Plan Commission

Agenda

Monday, May 23, 2022	7:00 PM	Council Chambers and Virtual
-----------------------------	----------------	-------------------------------------

SUBJECT: Consideration and possible action for a site plan for an ~11,326 SF private access road and storm water management at 114 S Ninth ST (Parcel WD-D0200-4).

EC-CONC WASHOUT 2 NO SCALE

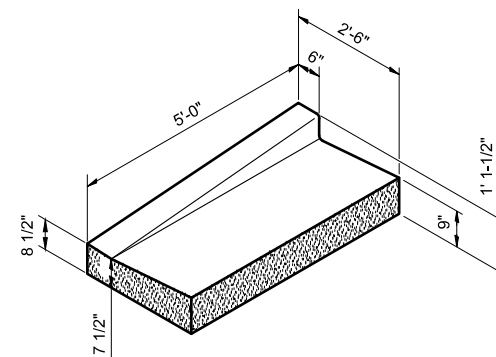
Show concrete washout area. **EC plan updated**

C400

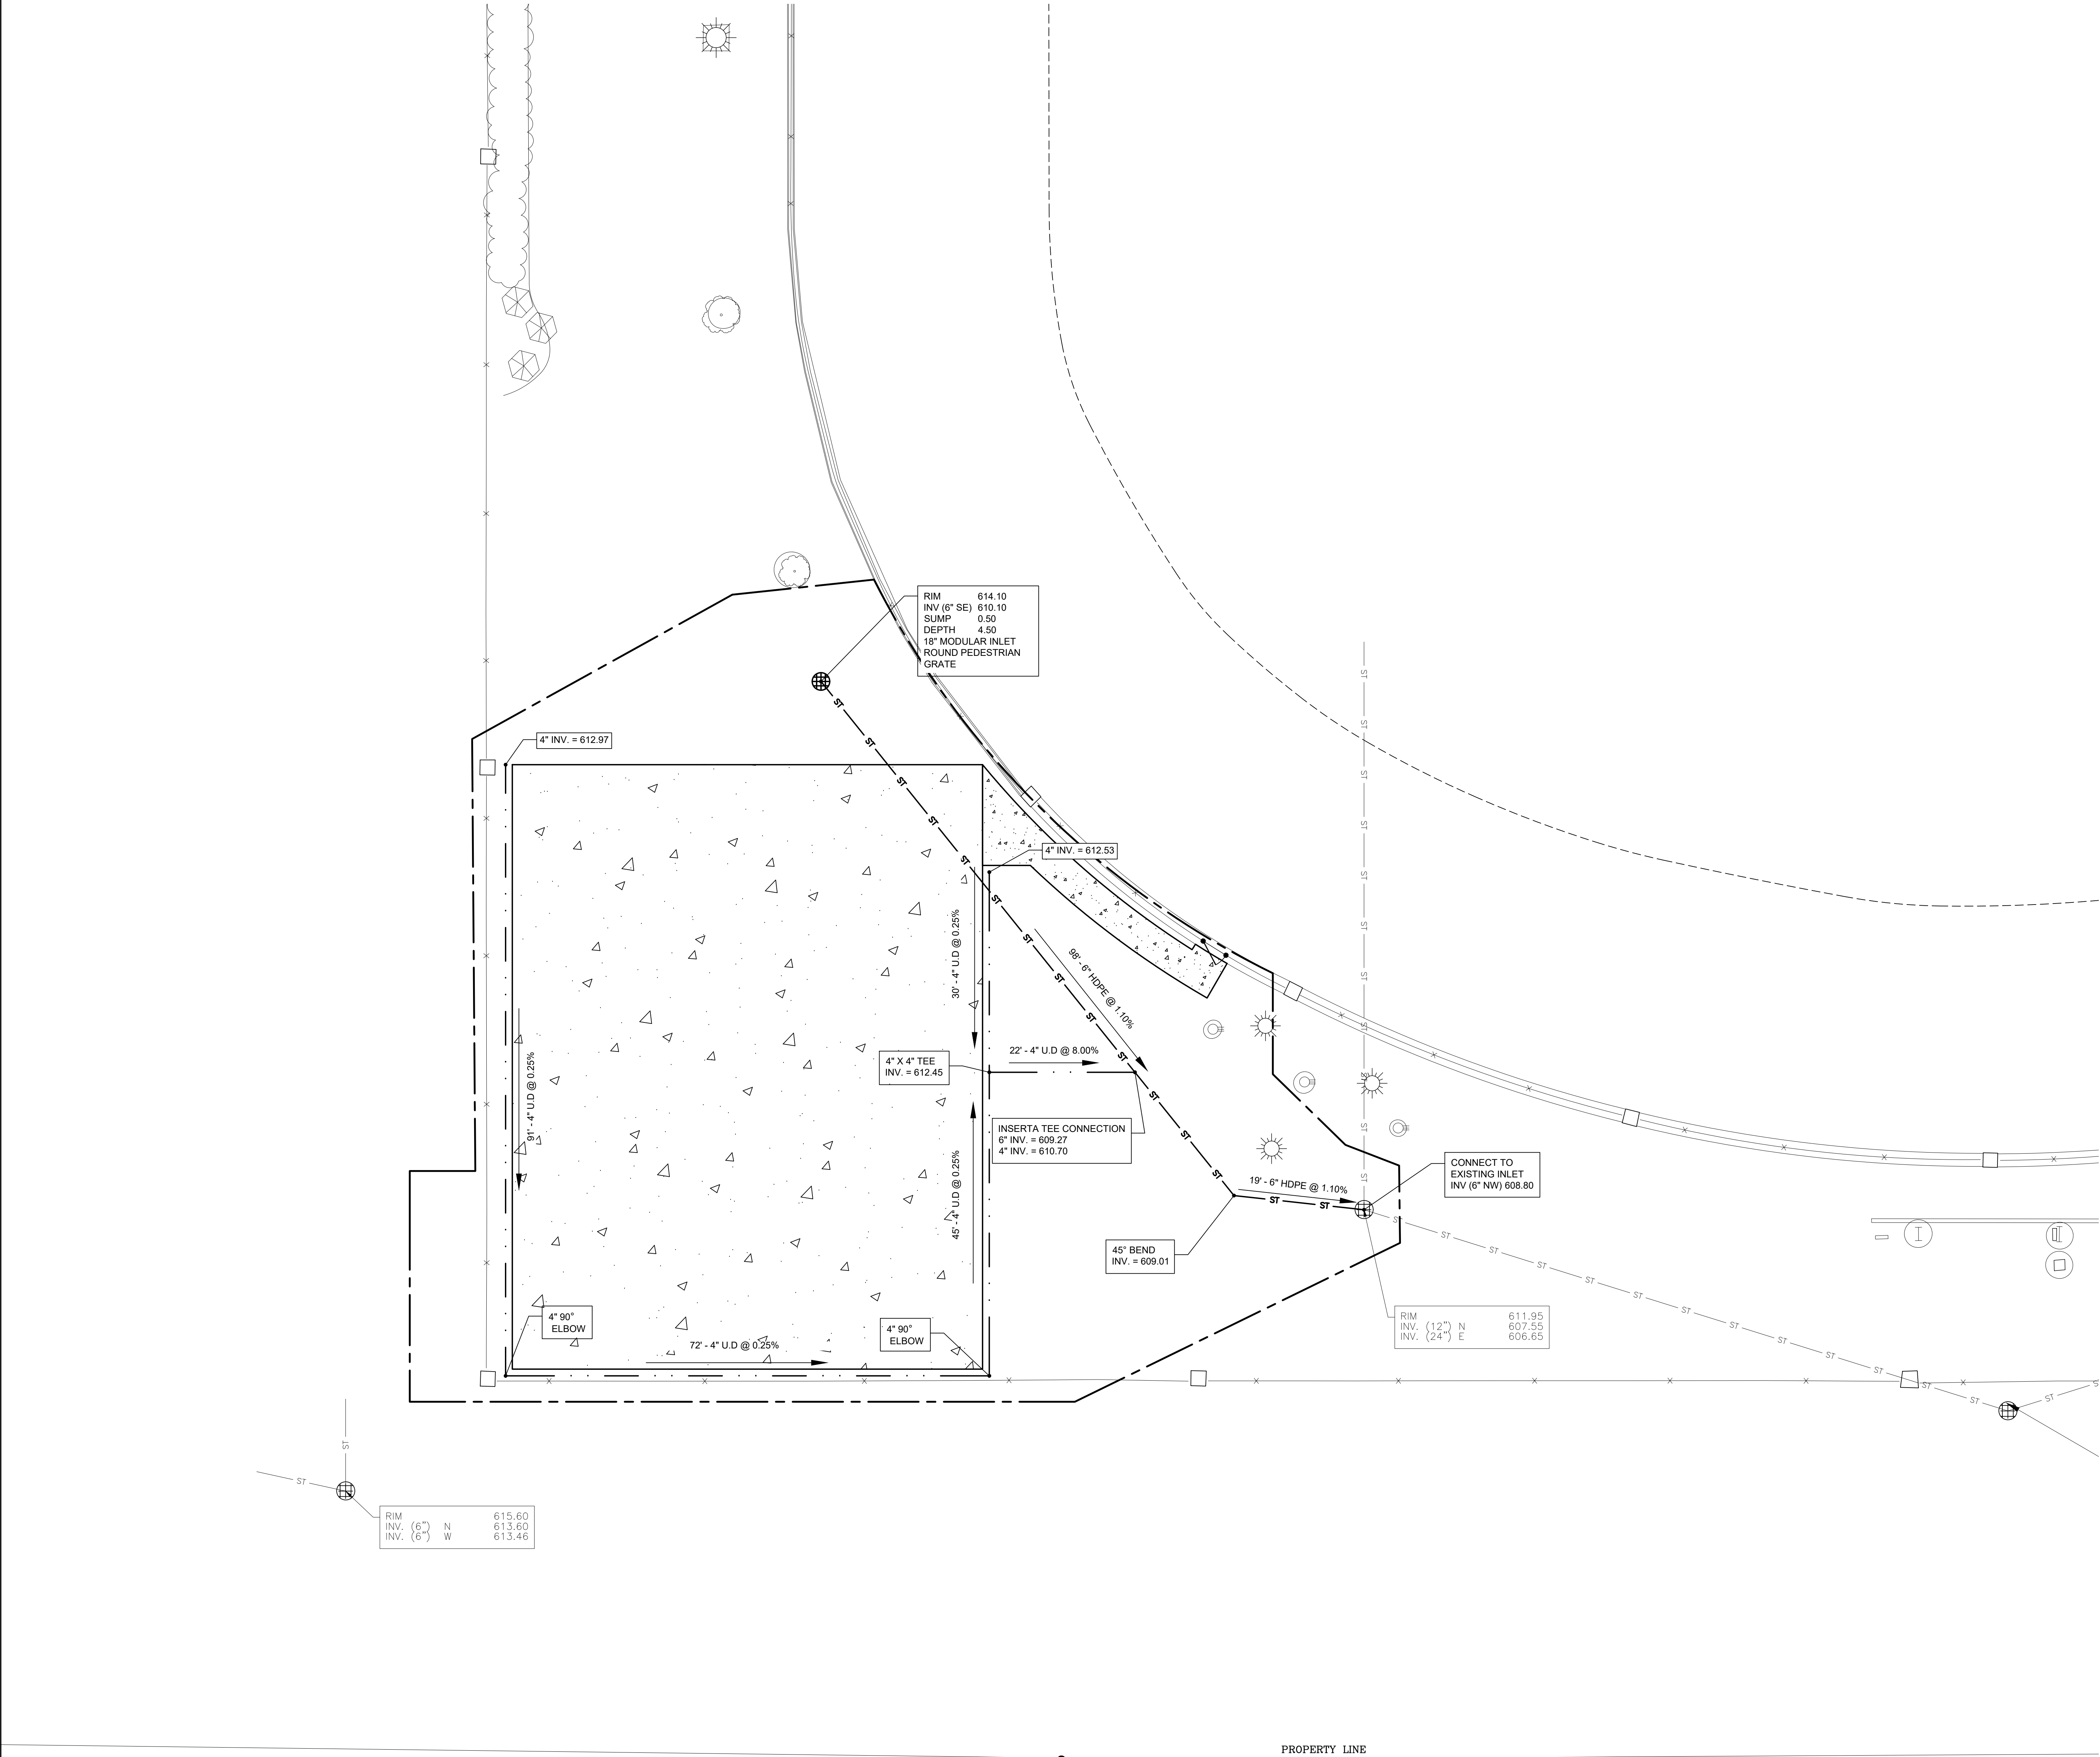
1. Sheet C400 - Identify where the site is being accessed from. Identify if a tracking pad and access path restoration is required/included.
2. Sheet C400 - Show stockpile location and appropriate erosion control.
